SUBJECT: Forwards revised responses for responses to two Matls  
 Engineering Branch questions.

January 6, 1982  
G02-82-04  
SS-L-02-CDT-82-002

Subject: NUCLEAR PROJECT NO. 2  
CHANGED RESPONSES TO MATERIALS  
ENGINEERING BRANCH QUESTIONS

VPF # **3133-31-3**

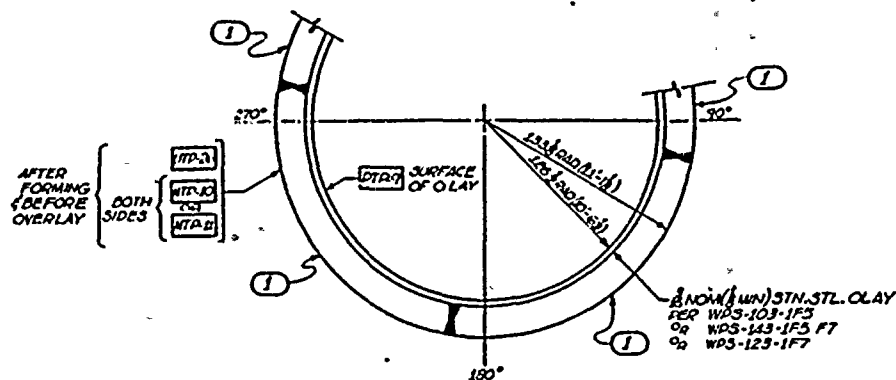
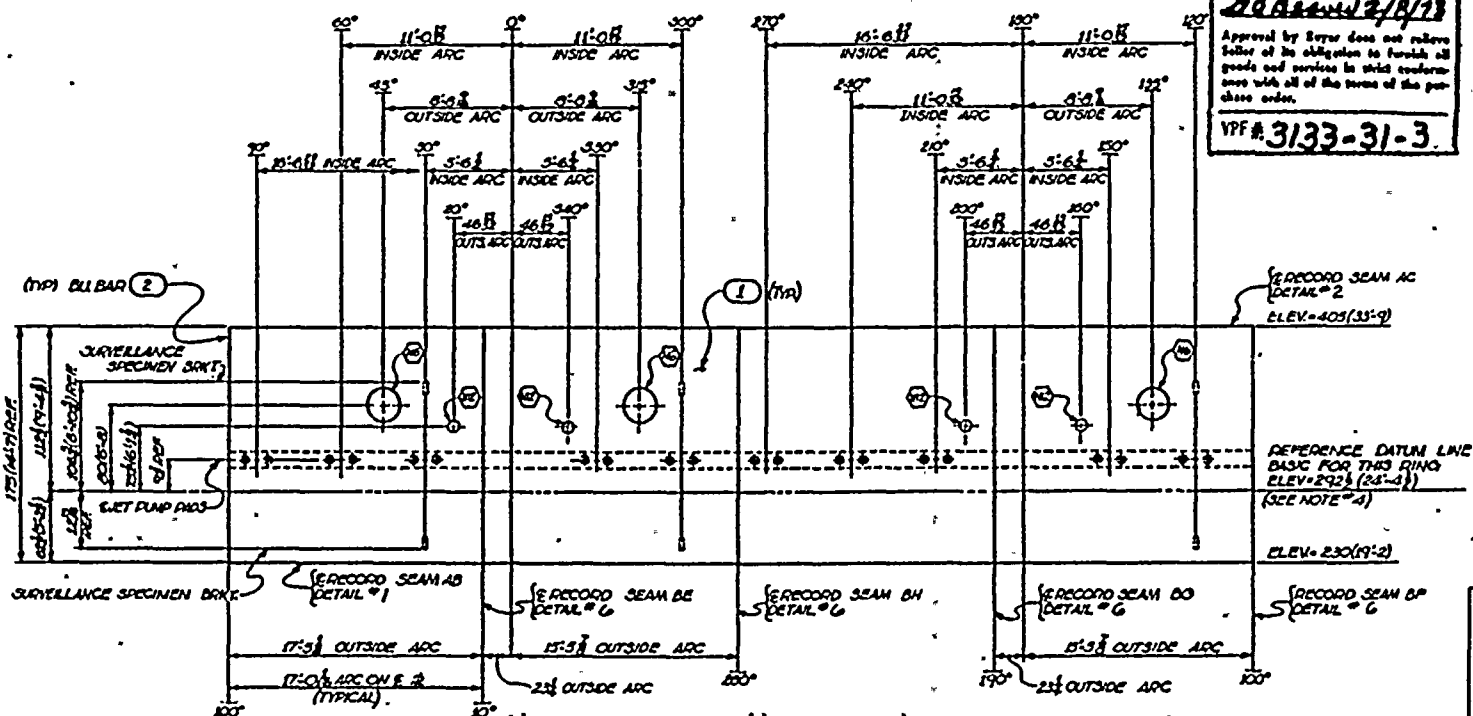
Indicate the inside diameter and minimum wall thickness of the reactor vessel beltline.

The inside diameter with clad = 251" (minimum).

Wall thickness with clad = 6.625%.

Clad thickness = 0.1875" (nominal).  
= 0.125" (minimum).

Refer to VFP No. 3133-31, which is included in the Appendix G and H submittal (see Reference 1 to Question 121.011).\*
